Re: Revisions to Waste Rock Soil Storage Pile Quantities, Sufco Mine, Canyon Fuel Company, LLC
Permit Number C/041/0002, Task ID#4702

Please find enclosed with this letter an amendment to the Sufco Mine Permit to address the revised soil storage pile quantities stored at the Waste Rock site. We have included two redline/strikeout copies of the text and of the map associated with this amendment. Revisions have been made to Chapter 2 of the M&RP, and Sections 2, 3 and 4 of the Waste Rock Site Text. Map 2 has been revised as has Figure 2A (combined pile cross sections and dimensions).

Title: Amendment to Revise Waste Rock Soil Storage Pile Quantities, Task ID#4702

FIGURE
2A

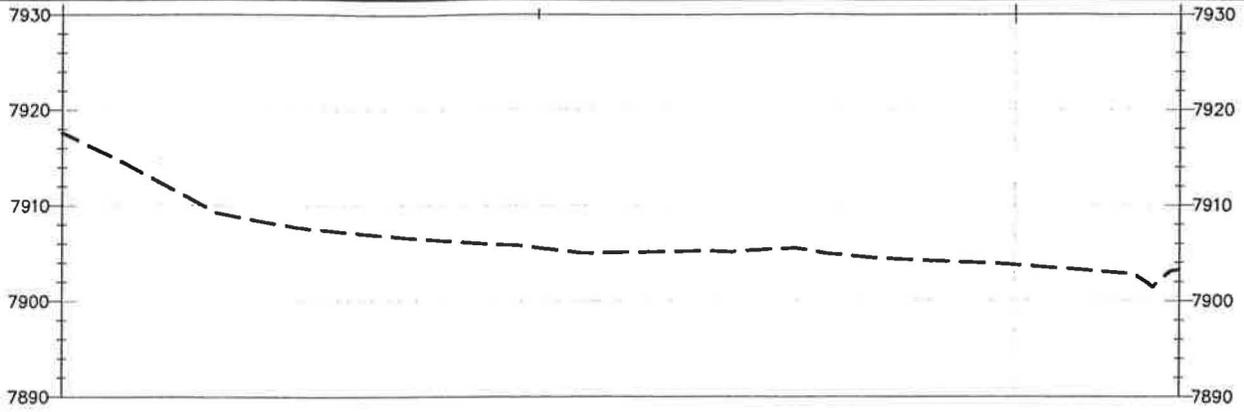
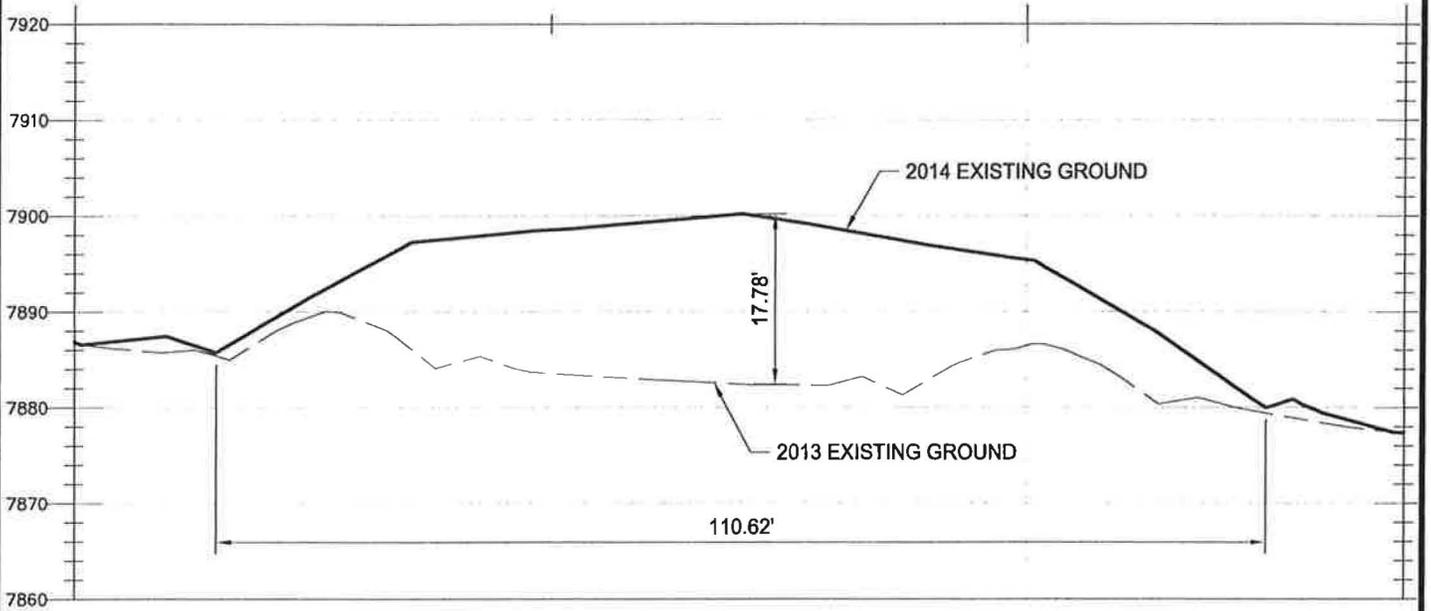
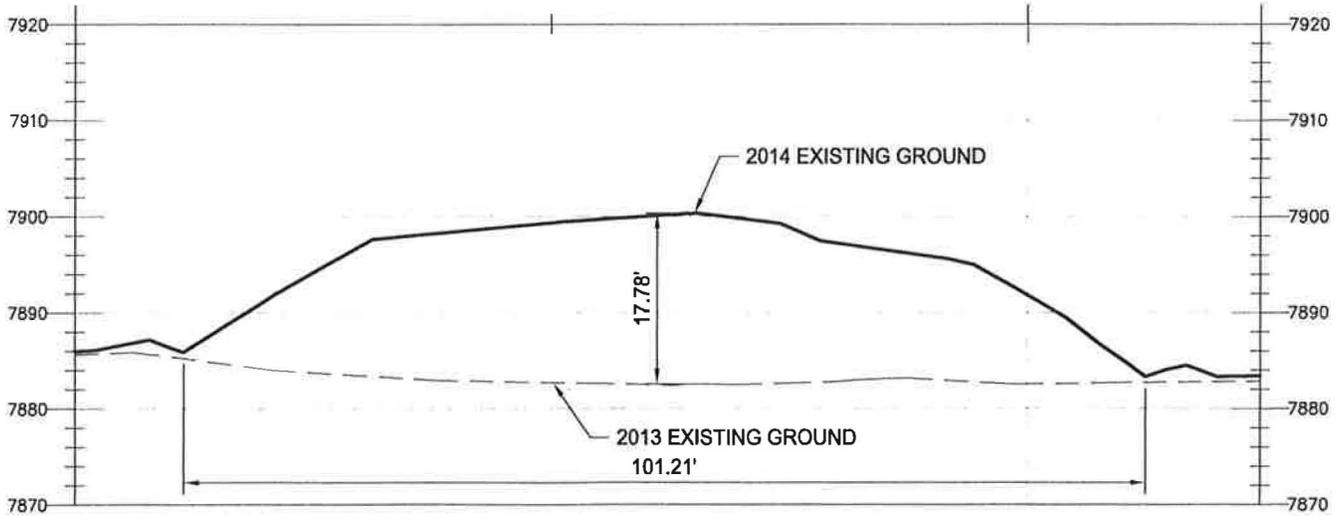
*** **Topsoil excavated for the Lift 5 Expansion was combined into a single pile with piles 2 and 3, Figure 2A shows dimensions and cross sections of this pile.**

UNDERGROUND DEVELOPMENT WASTE DISPOSAL SITE PLAN

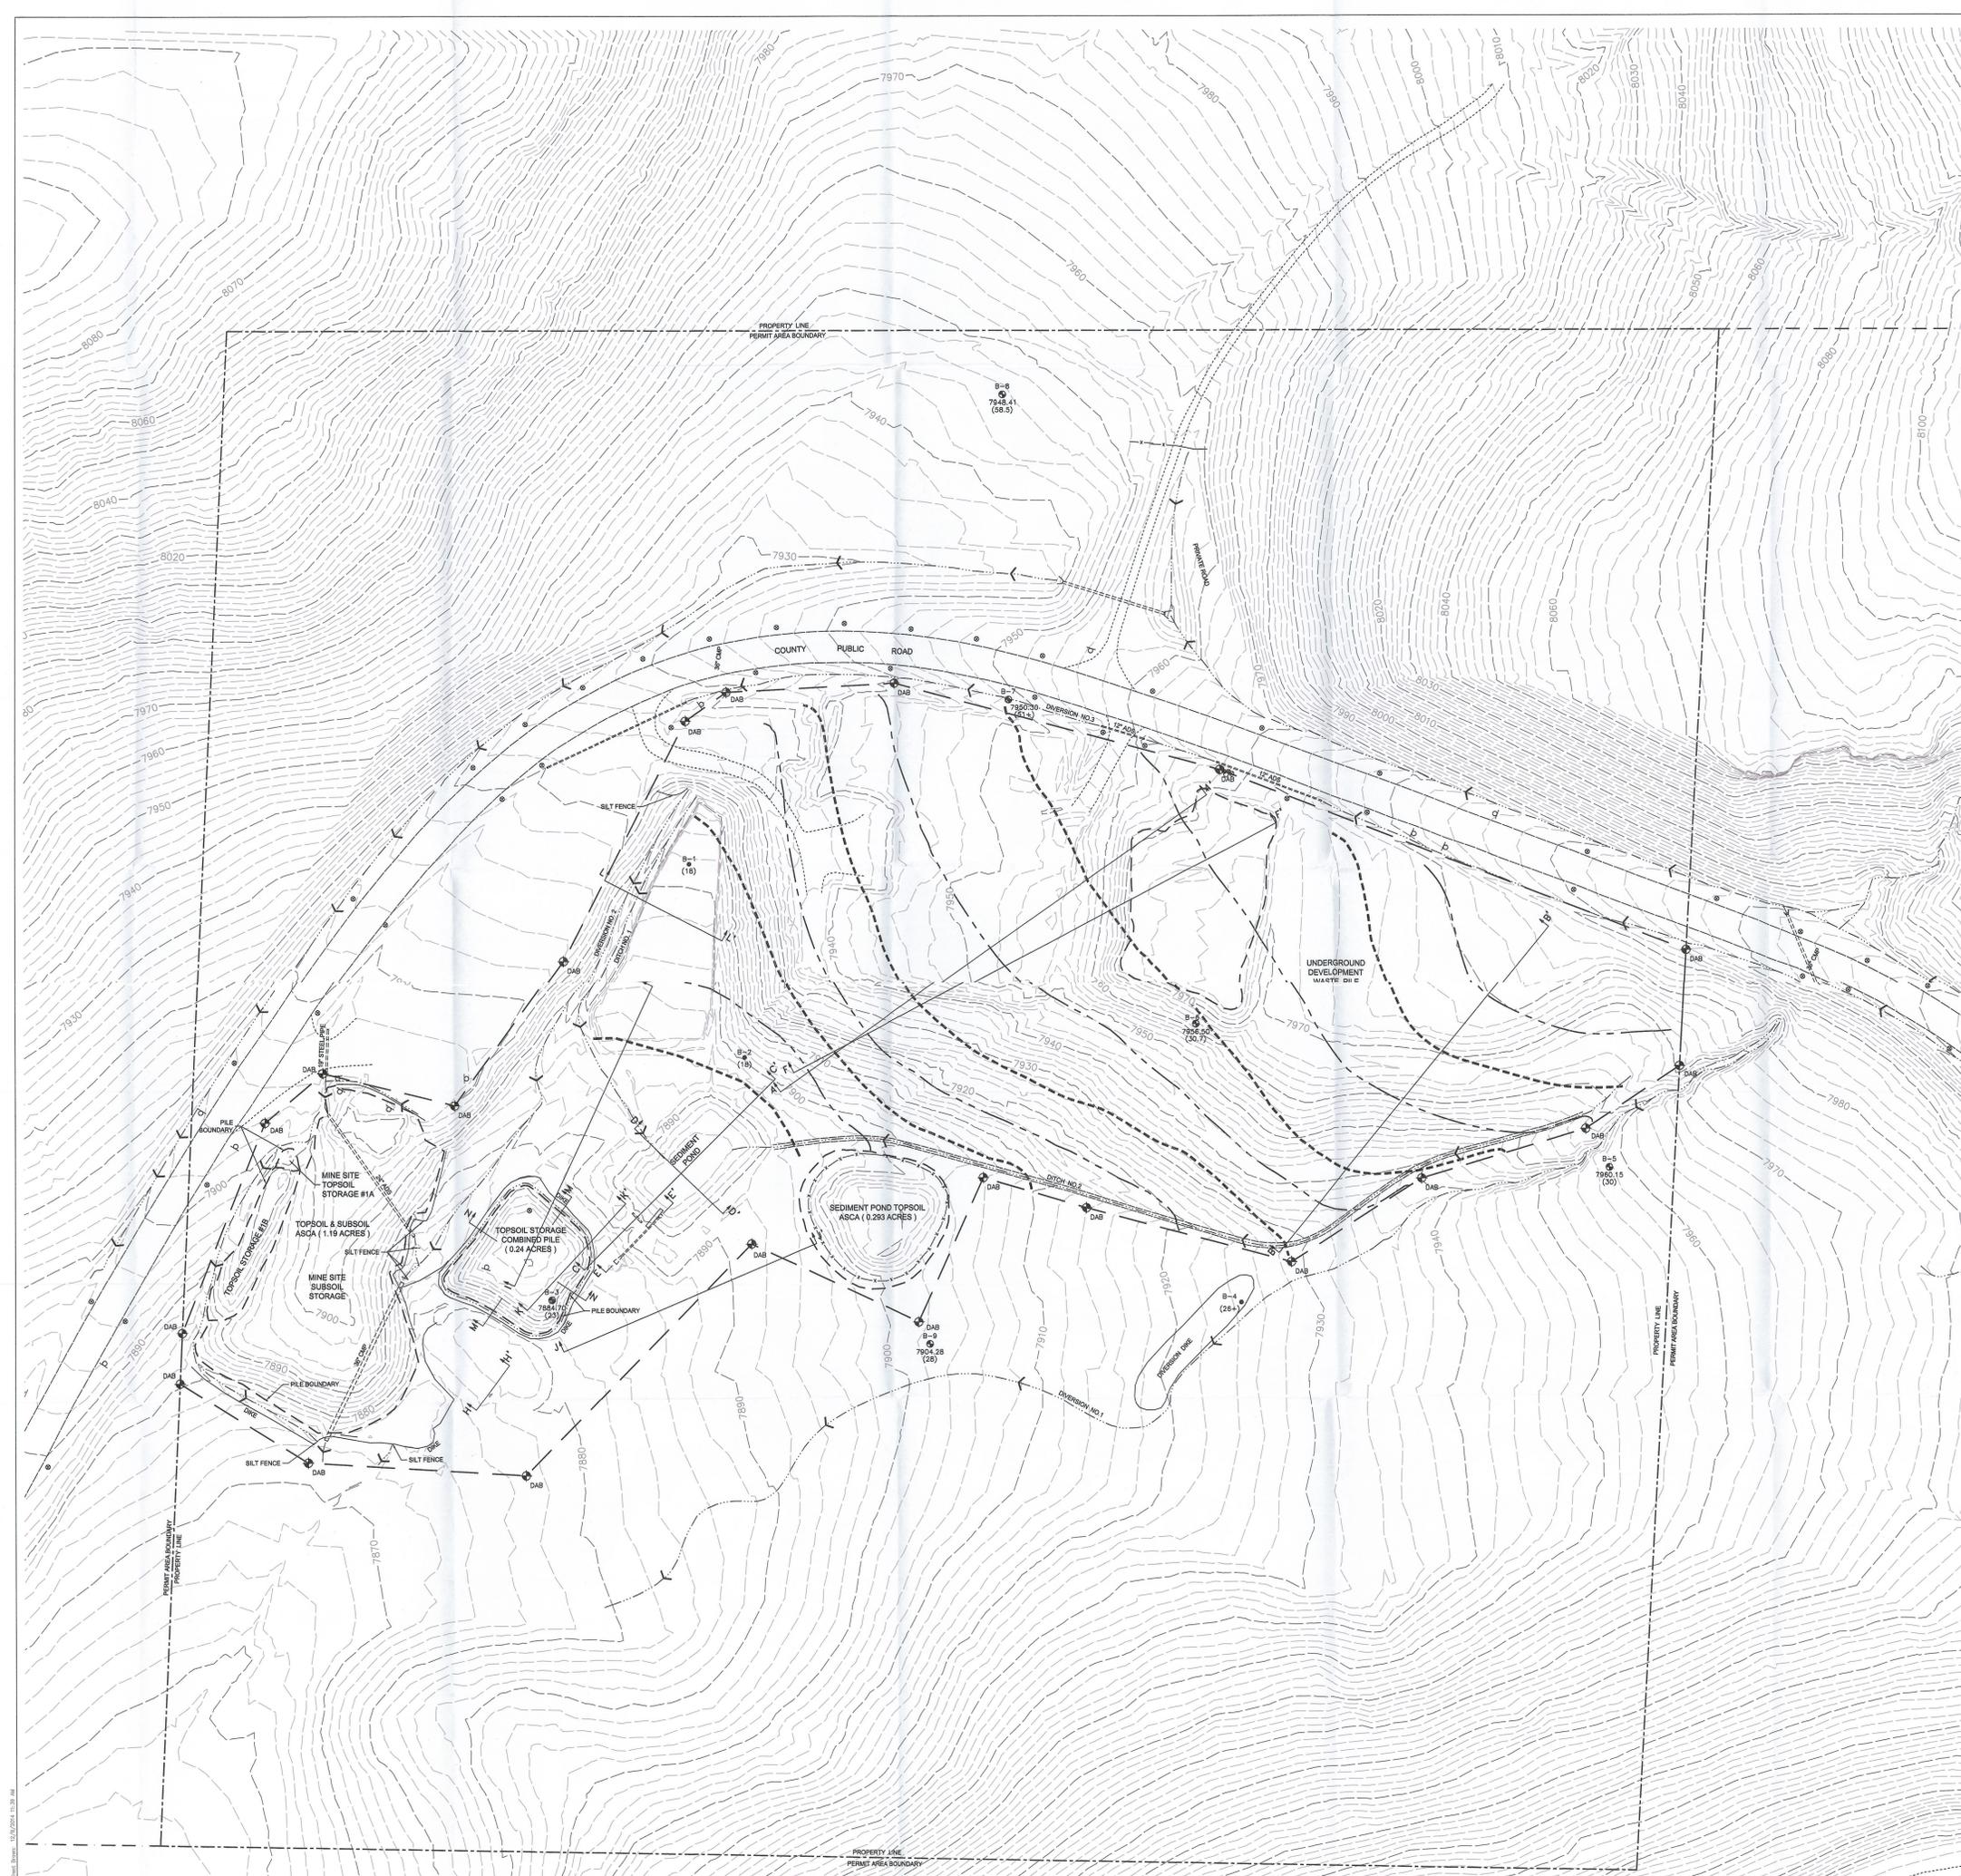
NO.	DATE	REQ. BY	DWG. BY	REMARKS
4	4/16/2013	M.L.D.	K.R.B.	
5	8/9/2013	VM	T.A.B.	
6	11/25/2014	VM	T.A.B.	
7	9/16/2014	VM	T.A.B.	
8	12/8/2014	VM	T.A.B.	Add See Lines W & N, changed thence
